A/C TYPE EC 155BA/C REGN 9M-SAS (6583)

## DEFECT AND RECTIFICATION WORKSHEET/CERTIFICATE OF RELEASE TO SERVICE

# ALERT SERVICE BULLETIN

**SUBJECT: INDICATING AND RECORDING SYSTEMS**  
Modification of the Power Supply to Landing Gear PCB 10 and 11 ALPHA

Figure 1

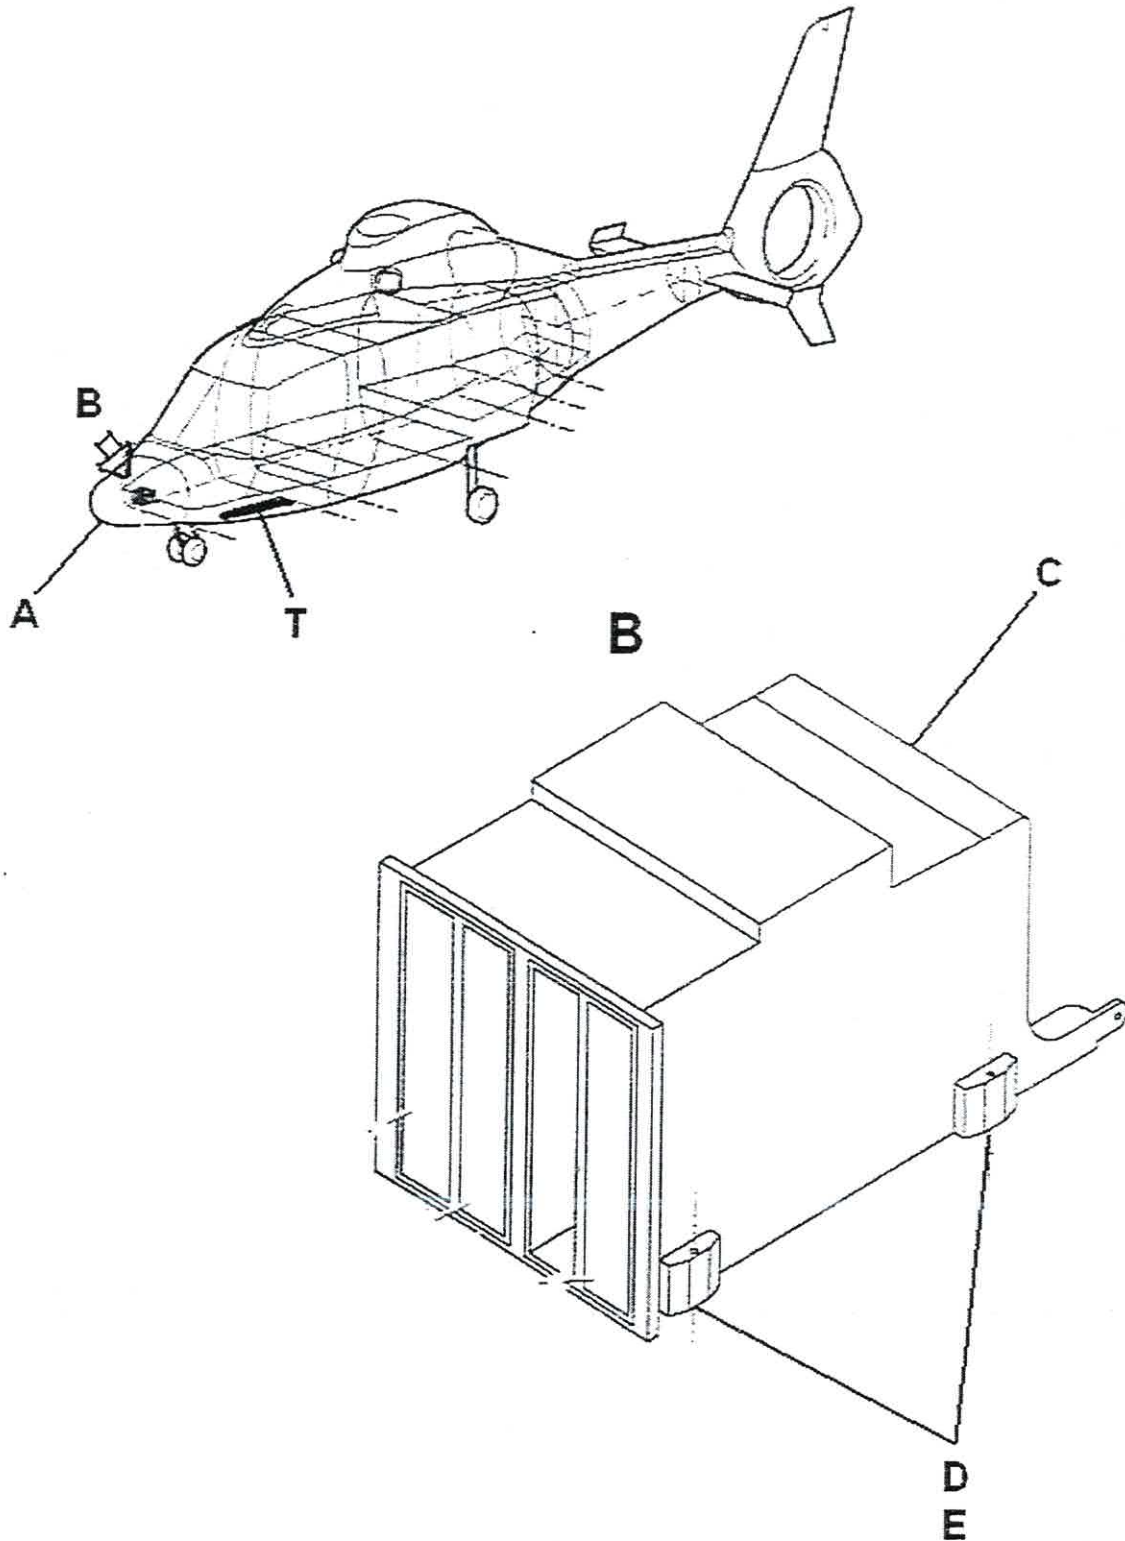
- Open radome (A).
- Remove LH landing light fairing (T) as per Task 53-55-00-061.

- Remove screws (D) and washers (E) securing PELIKAN rack (C).
- Remove PELICAN rack (C) rear connectors.
- Remove PELICAN rack (C).

- Install PELICAN rack (C) rear connectors.
- Install PELICAN rack (C) using screws (D) and washers (E).
- Install the radar antenna drive mechanism support as per Task 34-42-01-065.

Figure 2

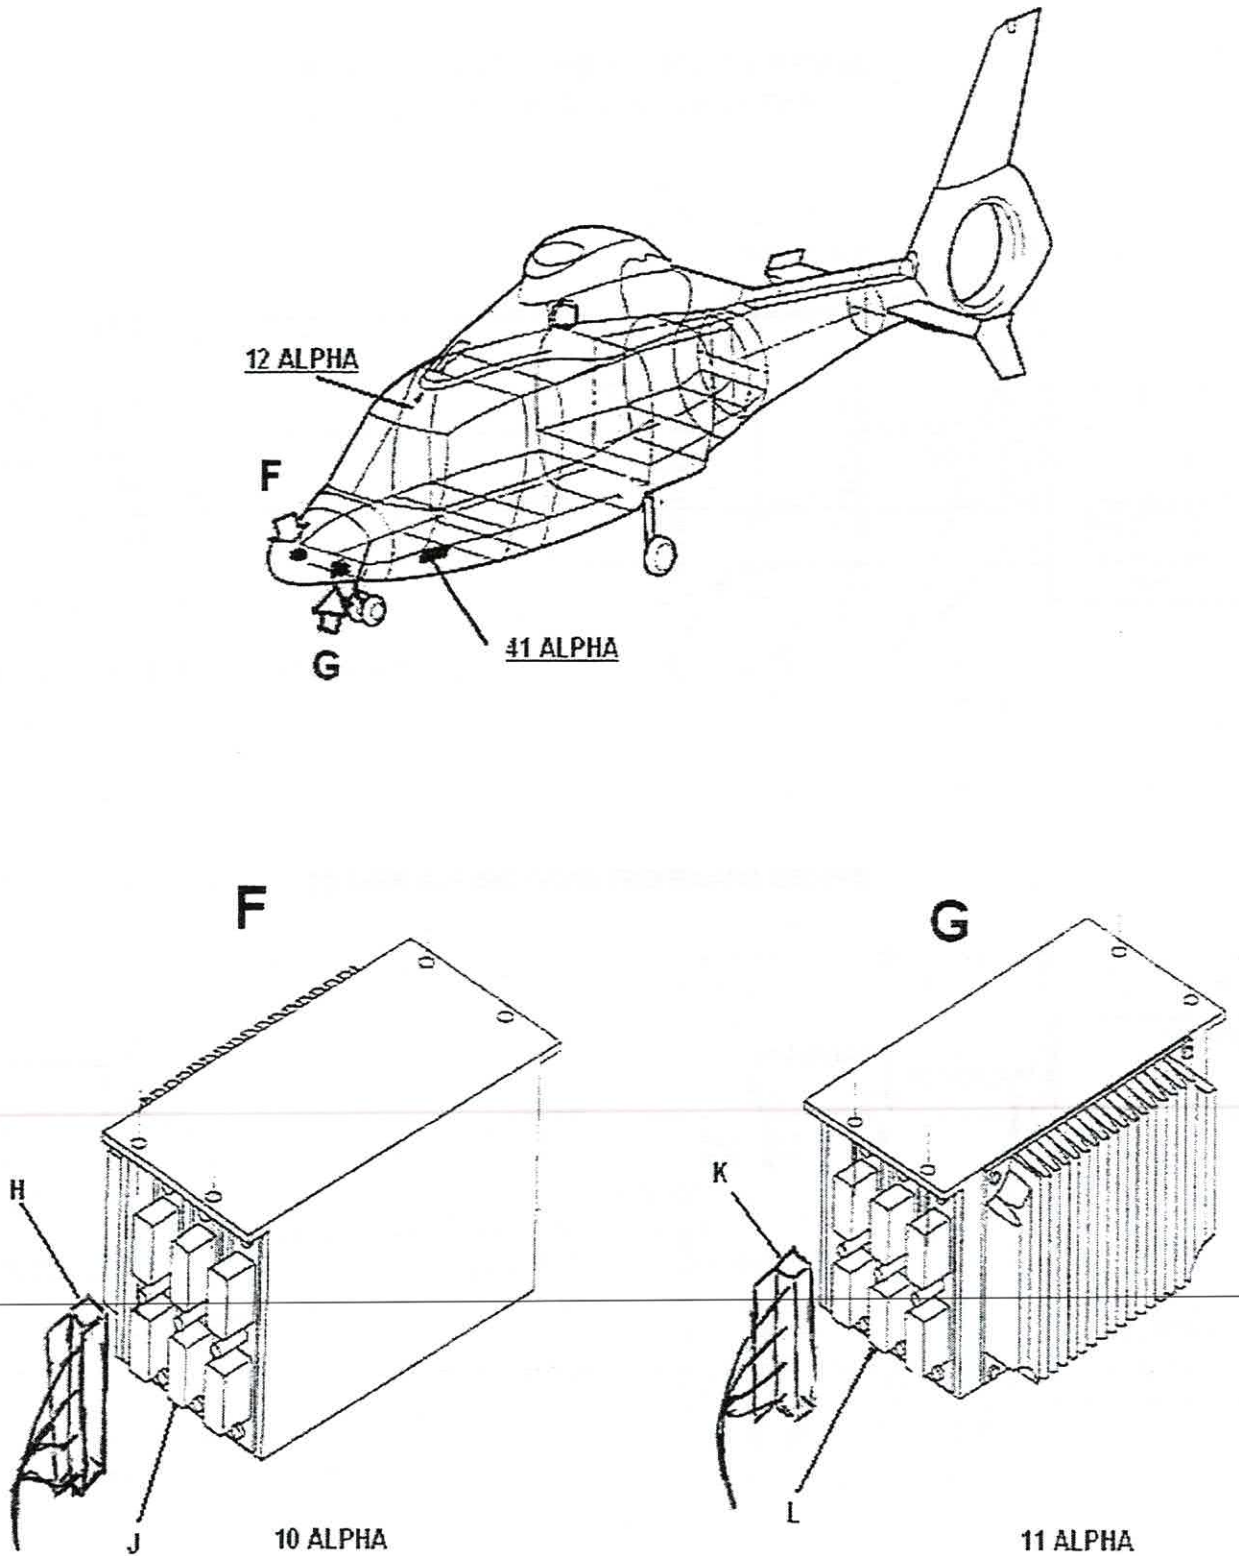
Modification of 10 ALPHA (Refer to Figures 2 and 3):

- Remove connector 10 ALPHA 2 (H) from fixed connector 10 ALPHA 2 (J).
- Remove identification marker 10 ALPHA 2 CP1 and retain it.
- Remove the clamp holding the harness and the green protective sheath on the cleat at the rear of connector 10 ALPHA 2 (H).

- Remove and discard diode (P).
- Remove and discard blanks (Q) on connector 10 ALPHA 2 CP1 (H).
- Disconnect wire REP5380A from terminal 1A and connect it to terminal 1C on connector (M).

- Disconnect wire 1GA24NE from terminal 2B and connect it to terminal 2C on connector (M).
- Take wire (8) and cut 2 lengths of 140 mm.
- Strip both ends of each length of wire (8).

- Crimp contacts (2) at one end of wires (8), and contacts (3) at the other.
- Connect a wire (8) between terminal 18 on connector 10 ALPHA 2 CP1(H), and terminal 1B on connector (M).

- Connect the other wire (8) between terminal 15 on connector 10 ALPHA 2 CP1(H), and terminal 2B on connector (M).

Figure 3

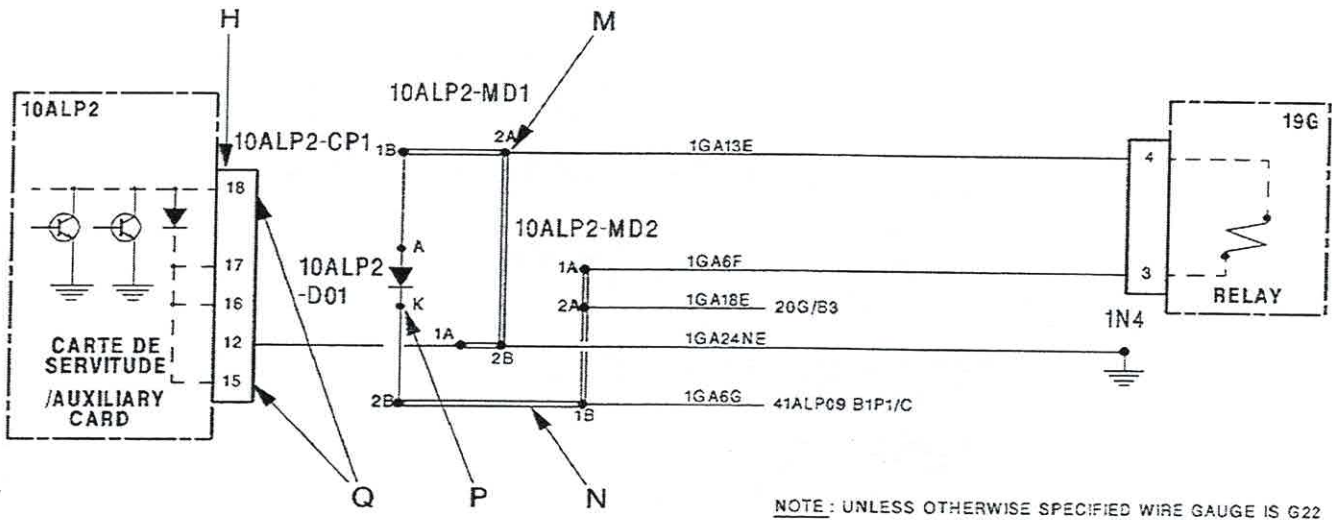
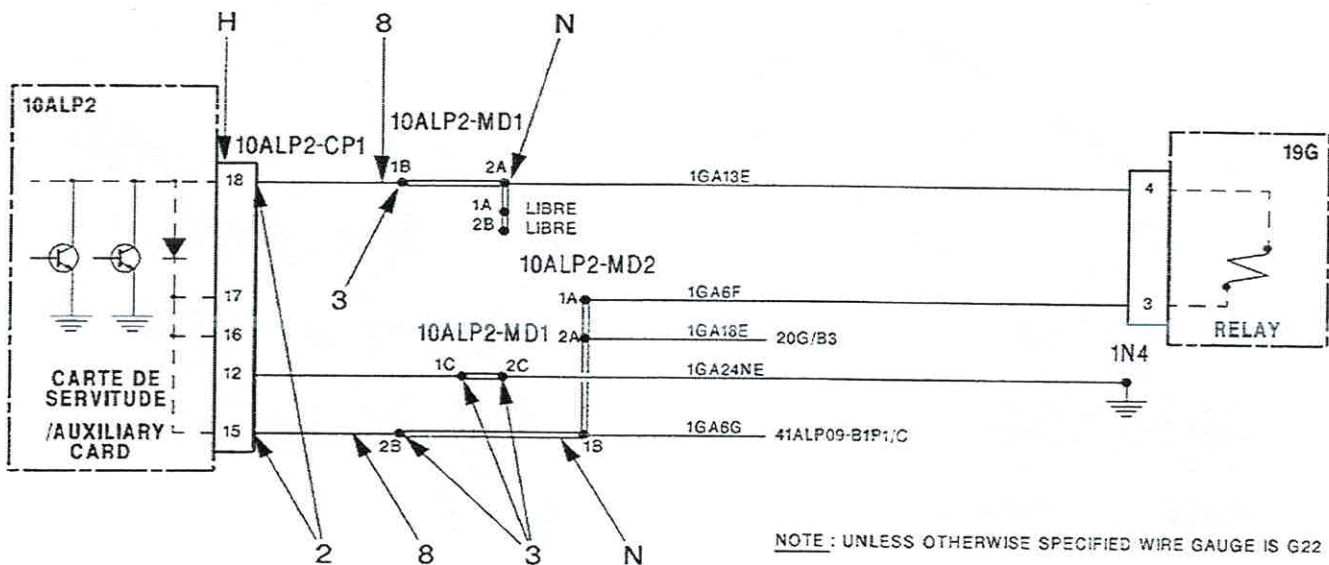
**APRES CROQUIS/POST DRAWING 365PCS 76 023  
AVANT MOD / PRE MOD 365P08.8837.01**

**APRES MOD/POST MOD 365P08.8837.01**

Figure 4

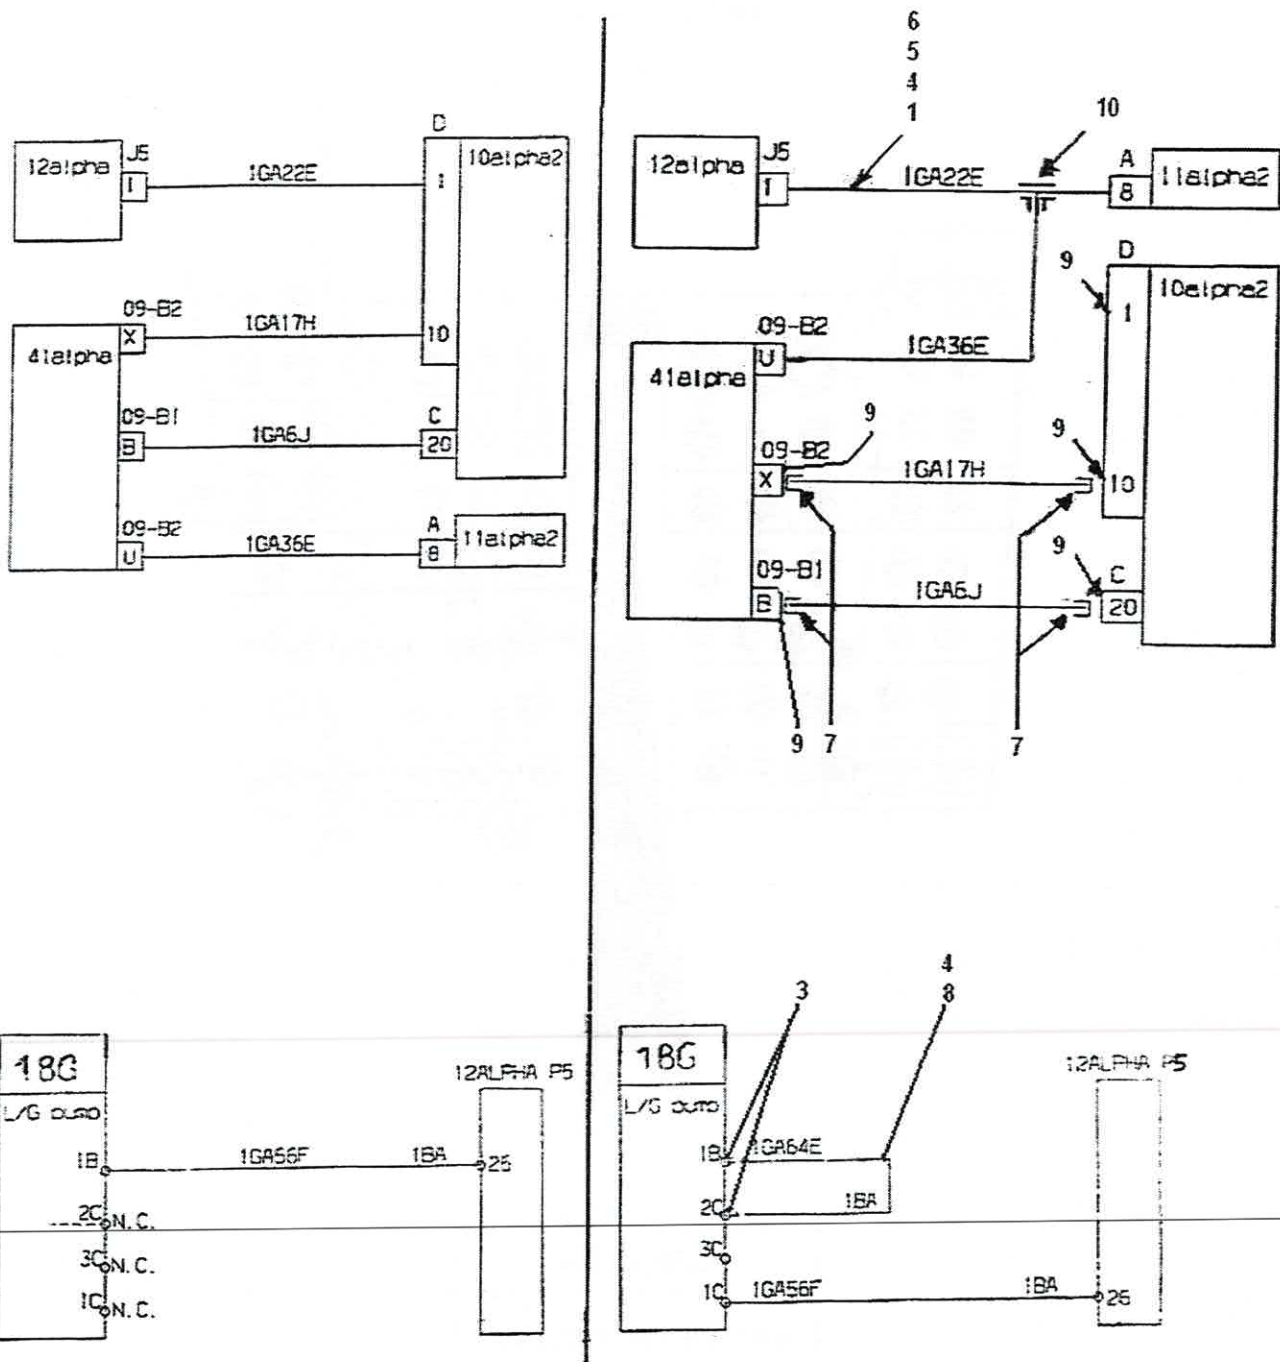
- Remove the clamps holding the green protective sheath on the harness.
- Unplug wire 1GA6J from connector 10 ALPHA 2 CP1.
- Fit cap (7) to wire 1GA6J.
- Fit blank (9) to terminal 20 on connector 10 ALPHA 2 CP1.

- Unplug wire 1GA17H from connector 10 ALPHA 2 DP1.
- Fit cap (7) to wire 1GA17H.
- Fit blank (9) to terminal 10 on connector 10 ALPHA 2 DP1.
- Unplug wire 1GA22E from connector 10 ALPHA 2 DP1.

- Fit blank (9) to terminal 1 on connector 10 ALPHA 2 DP1.
- Take wire 1GA22E out of electrical harness 10 ALPHA 2 DP1 at the rear of the PELICAN rack, where the main harness divides.

- Fit wire 1GA22E into green protective sheath (1).
- Route and secure wire 1GA22E, under its sheath, to the harness toward 11 ALPHA 2 AP1 using clamps (4), (5) and (6).

- Remove connector 11 ALPHA 2 (K) from fixed connector 11 ALPHA 2 (L).
- Remove identification marker 11 ALPHA 2 AP1 and retain it.
- Remove the clamp holding the harness and the green protective sheath on the cleat at the rear of connector 11 ALPHA 2 (K).
- Remove the clamps holding the green protective sheath on the harness.
- Connect wire 1GA22E to wire 1GA36E with extension lead (10) close to connector 11 ALPHA 2 AP1.

- Remove connector 41 ALPHA 09 from fixed connector 41 ALPHA 09.
- Unplug wire 1GA17H from connector 41 ALPHA 09-B2P1.
- Fit cap (7) to wire 1GA17H.
- Fit blank (9) to terminal X on connector 41 ALPHA 09-B2P1.
- Unplug wire 1GA6J from connector 41 ALPHA 09-B1.
- Fit cap (7) to wire 1GA6J.
- Fit blank (9) to terminal B on connector 41 ALPHA 09-B1P1.

Figure 5

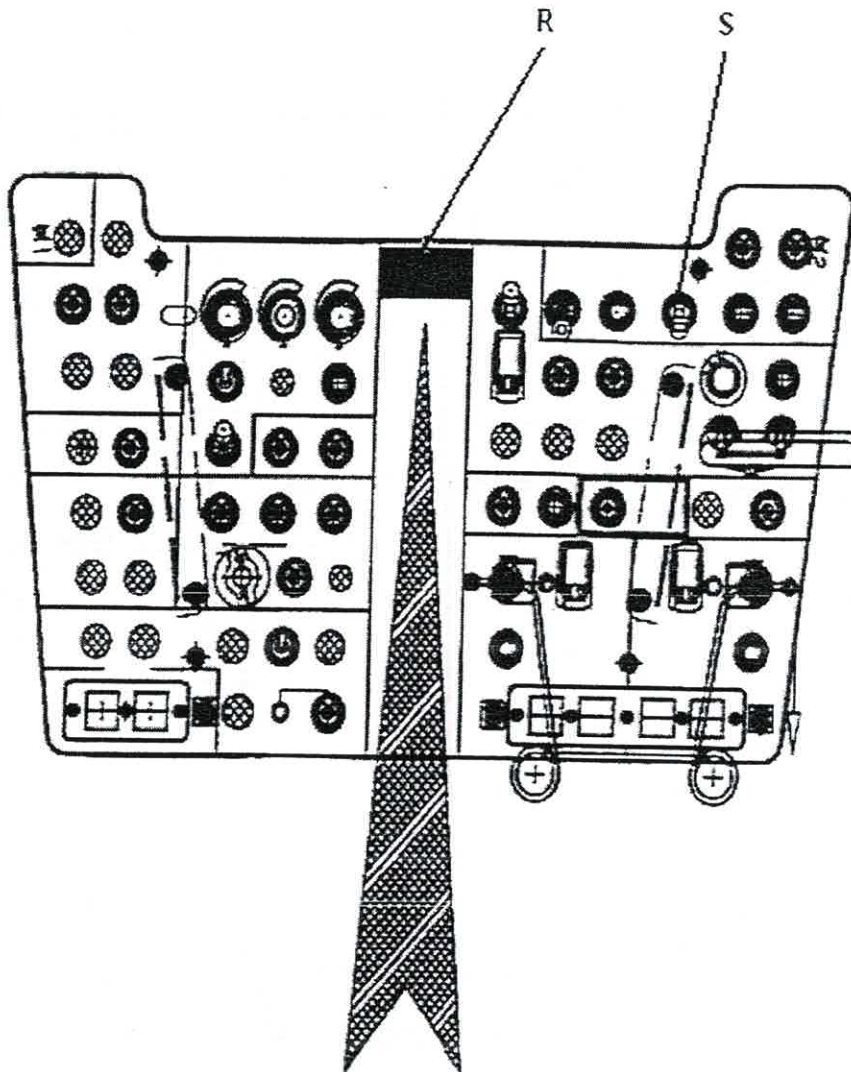
- Remove overhead panel 12 ALPHA.
- On "L/G PUMP" switch (S).
- Disconnect wire 1GA56F from contact 1B and connect it to contact 1C.
- Fit crimp contacts (3) to wire 1GA64E (8).
- Connect wire 1GA64E (8) to contacts 1B and 2C.
- Install clamps (4) to hold the wires on the harness of 12 ALPHA.
- Install overhead panel 12 ALPHA.
- Remove "LIMITATION" label (R) from overhead panel 12 ALPHA.

**CAUTION**  
EMER LG PUMP USE LIMITATION  
ON GROUND OPERATION TIME  
RESTRICTION ACCORDING TO  
TELEX ALERT 31A005

Fig. 1

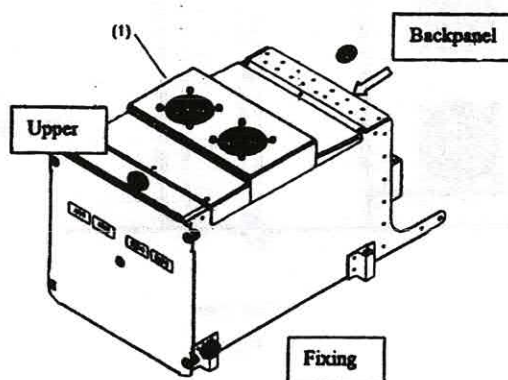
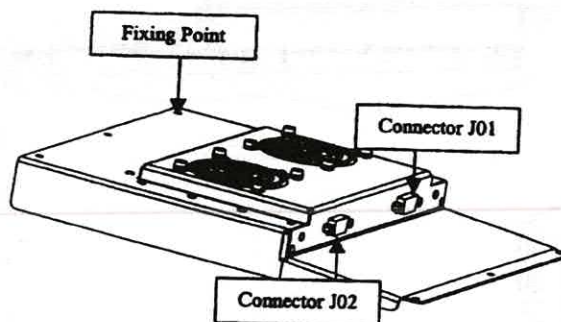
- (1) Remove the connectors connected to J01 and J02 (Fig. 2).
- (2) Remove the six screws and washers attaching the cooling module to the rack (1) Fig. 1.
- (3) Remove the cooling module PN E13106AA (1) Fig. 1.

- (1) Install the new cooling module PN E13106AB.
- (2) Attach the cooling module to the rack with the six screws and washers (on each screws put loctite 221 on two threads maximum).
- (3) Tighten the screws with a torque setting wrench set to 0.07 Nm.
- (4) Reconnect the two connectors to J01 and J02.

Fig. 3

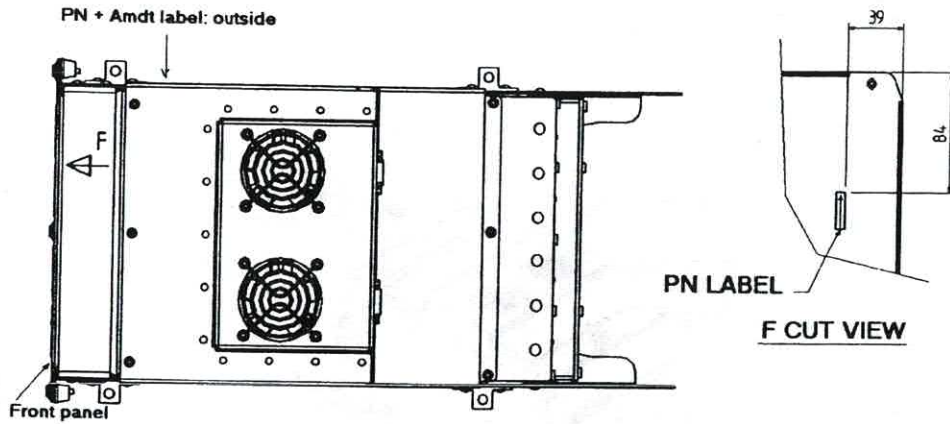
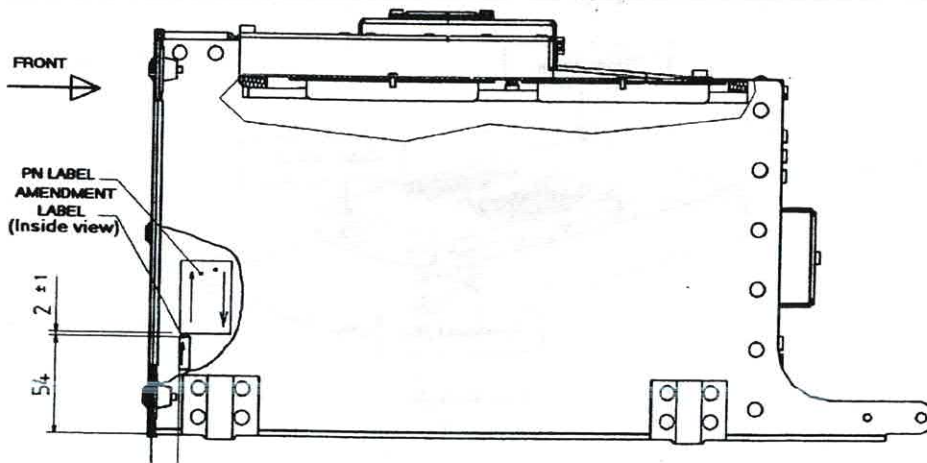
- (1) Remove the front panel Fig. 3.
  - (2) Replace the PN label (Fig. 3: PN label, F cut view).
  - (3) Replace the PN label (Fig. 3, outside) and write the Serial Number and the date on the label.
  - (4) Replace the modification label (Fig. 3: Amendment label, outside).
- Note:** For steps 5 and 6 it may be necessary to remove the optional module if it is present.
- (5) Remove the PN label (Fig. 4, inside) if present.

(6) Remove the modification label (Fig. 4, inside) if present.
